CONGRUENT SOFTWARE, INC.
98 Colorado Avenue
Berkeley, CA 94707
(510) 527-3926
(510) 527-3856 FAX

FROM: Peter Johansson
TO: T10 SBP-3 working group
DATE: September 20, 2001
RE: Bare-bones isochronous

The following normative text changes are proposed for a forthcoming SBP-3 working draft. Sections and clauses to be deleted in their entirety are listed below; the new text (as well as more piecemeal deletions) follows.

Figure 16 – Normal command block ORB (single data descriptor)

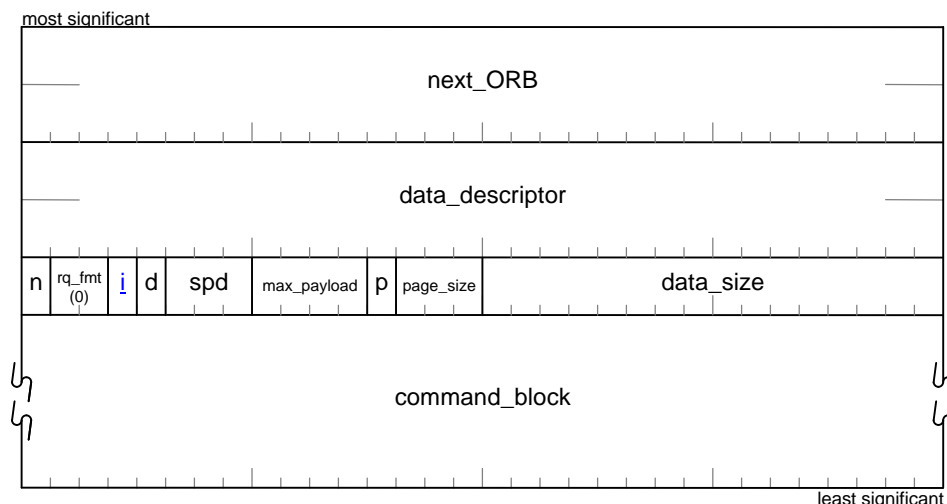
[The *isochronous* bit \(abbreviated as *i* in the figure above\) specifies the transfer method used for data associated with the ORB. When this bit is zero, Serial Bus read or write transactions shall be used to move data to or from the buffer. Otherwise, when *isochronous* is one, data transfer shall be effected by Serial Bus streams, *i.e.*, packets with a transaction code of \$A_{16}\$.](#)

[NOTE – The use of Serial Bus streams for the data transfer associated with a command does not preclude the use of *data_descriptor* and its associated fields to describe supplementary or parametric data pertinent to the command. When *isochronous* is one and *data_size* is nonzero, command set-dependent information correlates each data set with its transfer method. For commands that operate on a single data set, the *data_descriptor* fields are ignored when *isochronous* is one.](#)

Figure 27 – Create stream ORB

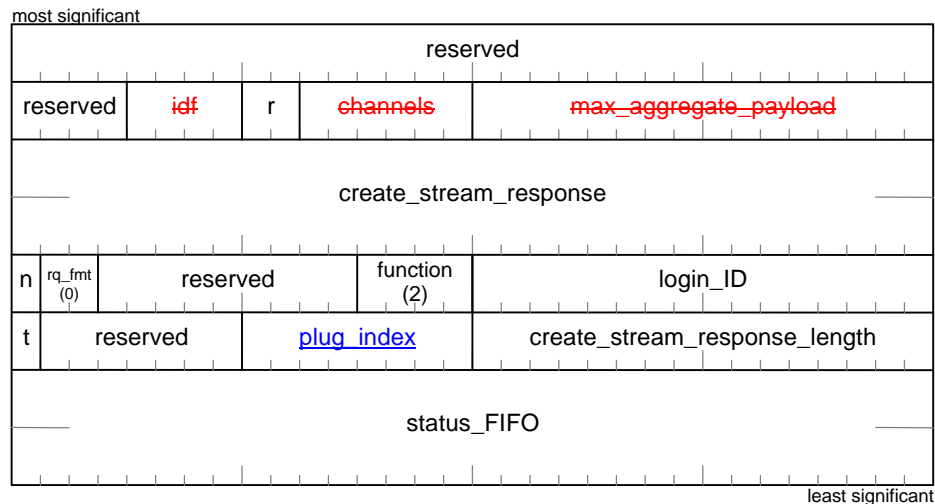
The *plug_index* field may uniquely identify a single source or sink or stream data within the context of the target. If *plug_index* is zero, command set-dependent methods specify the parameters of all stream data. When *plug_index* is in the range one to 1F₁₆, inclusive, it identifies a plug control register that mediates reception or transmission of stream data. The type of plug control register referenced, either an input or output plug control register, is determined by the value of the *talker* bit. Consult IEC 61883-1 for the specification of plug control registers. Other values of *plug_index* are reserved for future standardization.

Figure 28 – Create stream response

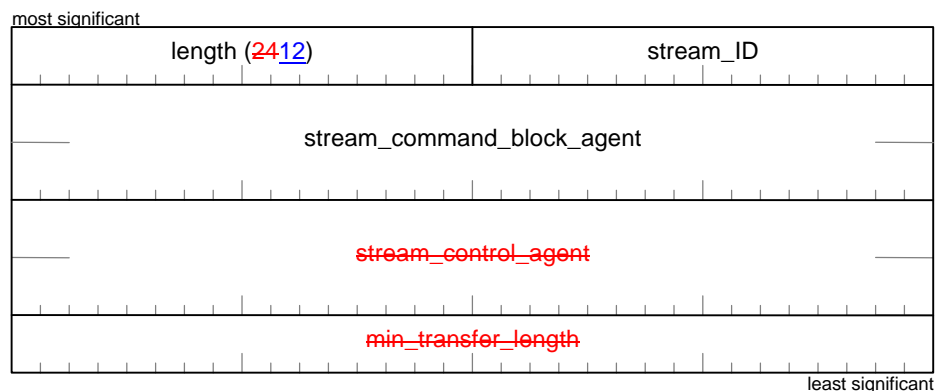
~~The *stream_command_block_agent* and *stream_control_agent* fields specify the base address of the agent's CSRs, which are defined in 6.4. Both fields shall conform to the format for address pointers specified by Figure 11. The *node_ID* portion of either field shall have a value equal to the most significant~~

~~16 bits of the target's NODE_IDS register. If the target does not implement a stream control agent, the contents of *stream_control_agent* are unspecified and shall be ignored by the initiator.~~

~~The *min_transfer_length* field advises the initiator of the minimum *stream_length* value desired by the target in stream command block ORBs in order to sustain the isochronous data transfer rate requested by the login. If the initiator presents any stream command block ORBs whose *stream_length* value is less than this minimum, the target may experience underflow or overflow in isochronous data while talking or listening at the requested rate. Even if this minimum is respected it is still possible for underflow or overflow to occur.~~

Figure 37 – Status block format

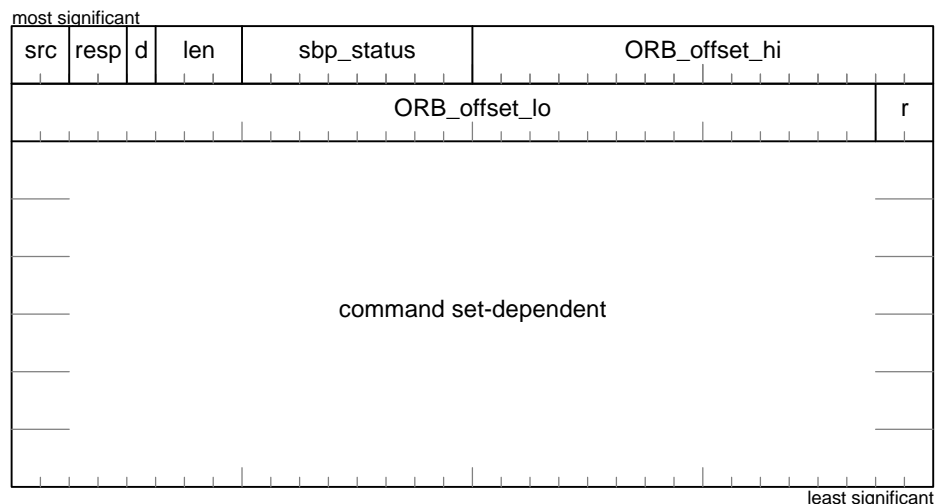
When *src* is zero, one [or three](#), the *ORB_offset_hi* and *ORB_offset_lo* fields together uniquely identify the ORB to which the status block pertains. Otherwise, if *src* is two, the *ORB_offset_hi* and *ORB_offset_lo* fields are ~~either ignored or redefined~~.

Figure H-1 – AV/C command frame ORB

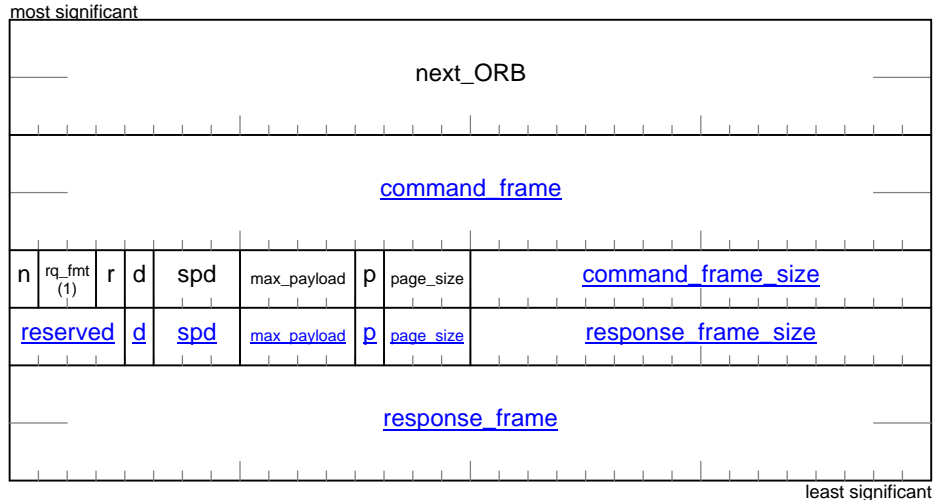
An AV/C command sequence consists of a command frame delivered to the AV/C device and one or more response frames returned to the controller. Both command and response frames are variable-length data structures between four and 512 bytes in length, and may be described by a normal command block ORB with dual data descriptors ~~A normal command block ORB can accommodate 12 bytes of command frame,~~ as illustrated below.

The *next_ORB*, ~~*data_descriptor*~~, *rq_fmt*, *spd*, *max_payload*, and *page_size* ~~and *data_size*~~ fields and the *notify*, *direction* and *page_table_present* bits (abbreviated as *n*, *d*, and *p*, respectively, in the figure above) are as specified in 5.1.2.1. ~~The AV/C commands described in the Version 2.0 1394 Trade Association specification do not reference a data buffer; consequently the *data_size* field is always zero in an AV/C command frame ORB.~~

The first data descriptor in the ORB, *command frame*, references a buffer that contains an AV/C command frame in the format specified by IEC 61883-1. The *direction* bit associated with this data descriptor shall be zero. Page tables are not used for AV/C command frames; the *page_table_present* bit shall be zero and *command frame size* shall be less than or equal to 512.

The second data descriptor in the ORB, *response frame*, references a buffer into which the AV/C device may store a response frame in the format specified by IEC 61883-1. The *direction* bit associated with this data descriptor shall be one. Page tables are not used for AV/C response frames; the *page_table_present* bit shall be zero and *response frame size* shall be less than or equal to 512.

Figure A-2— Status block format for AV/C response frame

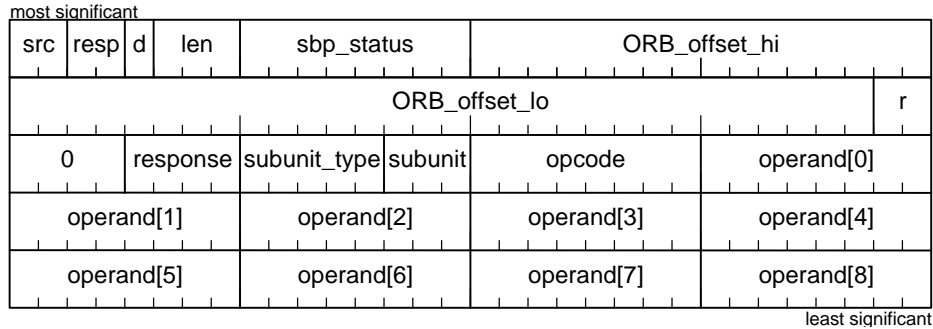
~~An AV/C response frame is a variable-length data structure between four and 512 bytes in length. The status block could hold up to 24 bytes of response frame, but since this exceeds the capacity of the AV/C command ORB the size of the status block is restricted to 20 bytes, as illustrated below.~~
